BNPM/TEN/ SHES /239/2017-18	BANK NOTE PAPER MILL INDIA PRIVATE LIMITED	Cover Sheet
	CORRIGENDUM NO. 1 Supply of heat exchanger system	SHEET 1 OF 2

**CORRIGENDUM NO. 1 DATED 20.11.2017**

**PROJECT : 12000 TPA BANK NOTE PAPER MILL PLANT**

**DIAGRAM A**

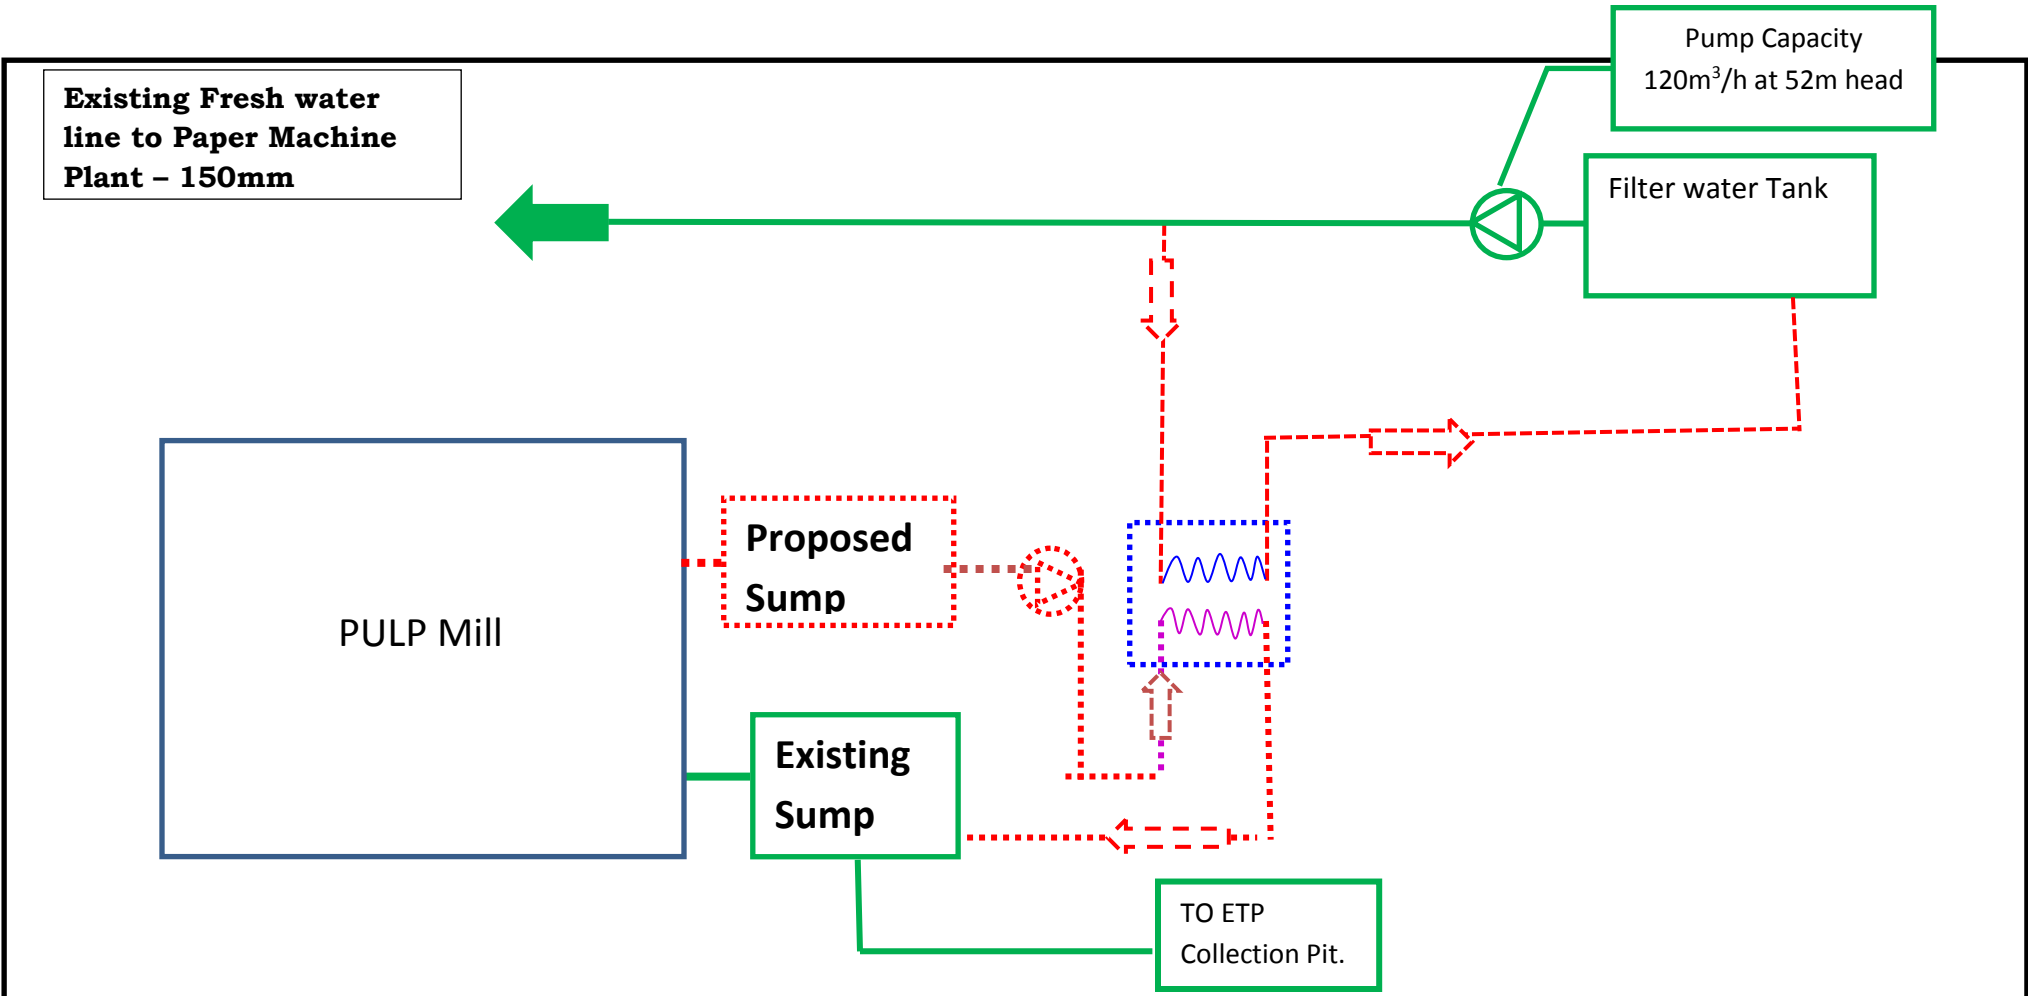
Sl. No.	Query raised by bidders	Action/Clarification incorporated in this Corrigendum
1	Tender specify for Spiral Heat Exchanger System - please inform that we can supply only spiral heat exchanger and water pump etc. will not be in our scope. We inform/confirm the same during our visit. Please clarify.	The supply, if any and erection of pump and pipelines shall be in Purchaser's scope. However, for more clarification please refer answer to query at Sl. No. 3.
2	Inlet cooling water to heat exchanger specified as Ambient : Please provide the ambient temp in deg. C , so that we can consider the same for design	The inlet Average temperature of cooling water shall be taken as 30° C.
3	Please provide the operating pressure, pressure drop & design pressure on both sides of heat exchanger. It's required for designing/providing the required thickness of plate material.	The effluent will be available at normal atmospheric pressure. If any collection tank and pumping arrangement is required for the effluent the bidder shall mention the sizing of the tank/ pump so required. The operating pressure for the heat exchanger shall be designed by the bidder, taking into consideration the cooling water connection shall be taken

from fresh water line which is running near to the installation of the SHE (150 NB size, Pump rated flow 120 m3/h at 50m head). Sizing of cooling water pipeline from existing fresh water line to the heat exchanger and back to the clarifier in WTP should be provided by the bidder to BNPM (located at around 40m from the location of the Heat exchanger). (Refer attached Diagram A)
4	Also please note under special note of technical spec, it's mentioned as party is advised to visit the site to understand the requirement. -Please get it clarify (As we have already visited the site).	As you have already visited the site, you may not require to visit again. However, you should confirm you have understood the scope of work as per requirement.
5	What is maximum flow rate of cooling water you can provide?	The cooling water line taping needs to be taken from the fresh water line (150 NB size, Pump rated flow 120 m3/h at 50m head) located at around 40m from the location of the Heat exchanger. Sizing of cooling water pipeline from existing fresh water line to the heat exchanger and back to the clarifier in WTP should be provided by the bidder to BNPM. Flow rate of cooling water shall be decided by the bidder (however maximum 50m3/hr of cooling water can be provided) and the pipeline sizing shall be done accordingly and submitted by the bidder.

Note: Mentioned in dotted line shall be designed by the bidder. Pipeline/equipment sizing shall be mentioned by the bidder.
